# **Phase Only Jitter (179.9.4.6 proposed revisions)**

## **Presented to IEEE P802.3dj Joint Electrical/Optical/Logic ad hoc**

### **Version 1.1: January 09, 2025**

**Associated comments (D1.3): 305, 219, 220, 221**

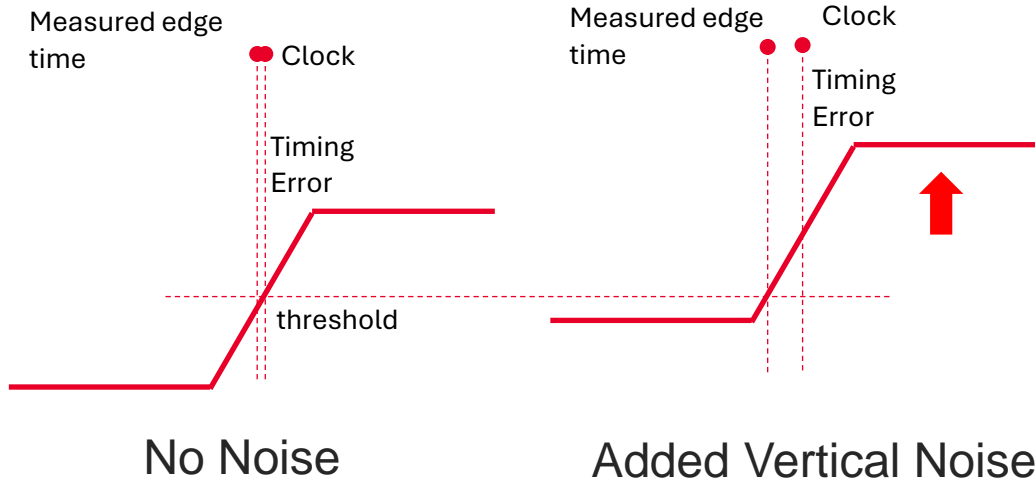
[Current Text]:

- The estimated probability distribution  $f_J(t)$  is calculated as specified in 120D.3.1.8.1, except that only the transitions R03 and F30 are used.
- JRMS03 is defined as the standard deviation of  $f_J(t)$ .
- Jnu03 is defined as the time interval that includes all but  $10^{-n}$  of  $f_J(t)$ , between the  $5 \times 10^{-(n+1)}$  and the  $1 - 5 \times 10^{-(n+1)}$  quantiles of  $f_J(t)$ .

[Proposed Text]:

- The measured probability distribution  $f_J(t)$  is calculated as specified in 120D.3.1.8.1.
- JRMS is defined as the standard deviation of  $f_J(t)$ .
- JHRMS is the measured RMS value of **phase jitter** and has all noise elements removed. For example, JHRMS would correspond to the SQRT(Y-intercept) of a linear fit to a set of  $JRMS^2$  values versus  $(1/Slew-rate)^2$ , using the edges defined in 120D.3.1.8.1 **or any additional edges as needed**.
- Jnu03 is defined as the time interval that includes all but  $10^{-n}$  of  $f_J(t)$ , between the  $5 \times 10^{-(n+1)}$  and the  $1 - 5 \times 10^{-(n+1)}$  quantiles of  $f_J(t)$ , **where  $f_J(t)$  restricted to 3 level transitions**.
